Planning Commission Meeting Date: November 8,
2023

To: Planning Commission
From: Shane Witham, Planning Director
Subject: Appeal: Partition/Major Variance Case 2023-12

**KEIZER PLANNING DEPARTMENT
NOTICE OF DECISION
Partition Case 2023-12**

PARTITION/MAJOR VARIANCE CASE NO. 2023-12
APPLICANT – MICHAEL AND SUSIE LE
ADDRESS – 527 DEARBORN AVENUE N

EXHIBIT 1

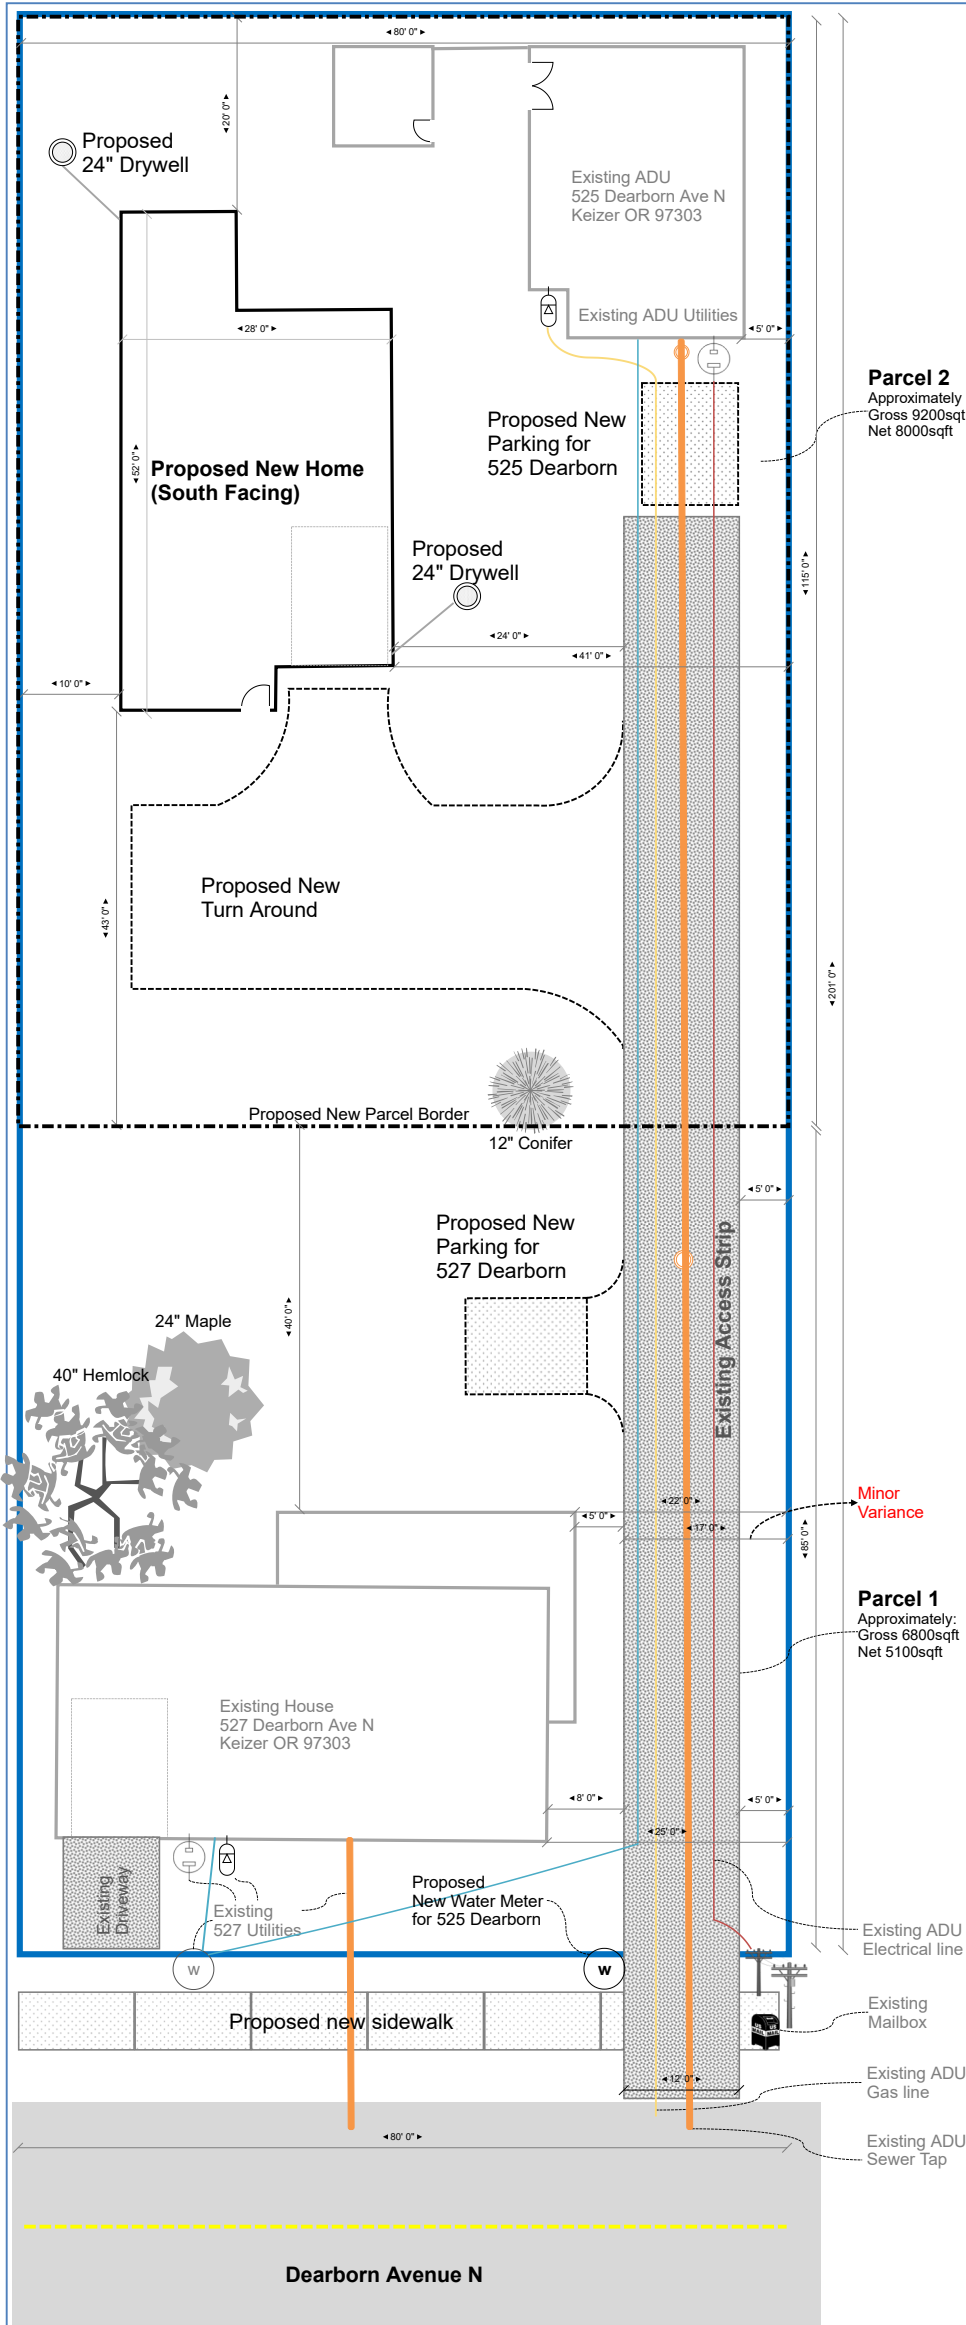
- A. An appeal was received on September 28, 2023. The appeal form is attached for your reference. The appeal form cited the following errors:
1. Site Map Exhibit 1 - errors and omissions - setbacks and trees
 2. Easement not legal - can't grant yourself an easement.
 3. Not verified this additional housing needed in Keizer.
 4. No verification this won't add to Keizer blight.
 5. Criminal acts committed in pursuit of partition nullify it.

Turn-around: The KDC requires a turn-around for access easements serving two or more dwelling units. The access easement is proposed to serve both lots, therefore a turn-around is required. The applicant has submitted a site plan (Exhibit 1) that shows a turn-around located on Parcel 2. This will be reviewed by the City Engineer at the time of plat review to ensure dimensions and turning radius requirements are met.

I have a simple request also I would like to suggest that the proposal drawing does not look to be the correct scale for that property. I have walked that property before the Le's bought it and looked at satellite photos of that property going back to 2016 I suggest you do the same before allowing this to happen. John Hill was a working contractor up till recently and my husband works in the trade and they both say that the drywell for the proposed SFD in the back is too close to the fence. Has that code changed from the 10ft that it was before?

It is not clear in the site plan how the proposed SFD will be positioned regarding front, side and back of the building and the compliance with setback requirements. In addition the city code prohibition of parking in the access easement, including the turnaround, raises concern that adequate parking spaces are provided. It appears that the development code requires 3 parking spaces unless on-street parking is available. Does the turnaround incorporate the required 60' diameter?

- 6. A site plan, prepared by a licensed engineer or surveyor must be submitted to the City of Keizer Planning Department demonstrating the existing dwelling on Parcel 1 meets the minimum rear setback requirement of the RS zone.

- 7. Unless waived in writing by the adjacent property owners, a 6’ sight-obscuring fence, wall, or hedge is required along the east side of the access easement to provide screening to the adjacent property. If waived, documentation must be submitted to the City of Keizer Planning Department.
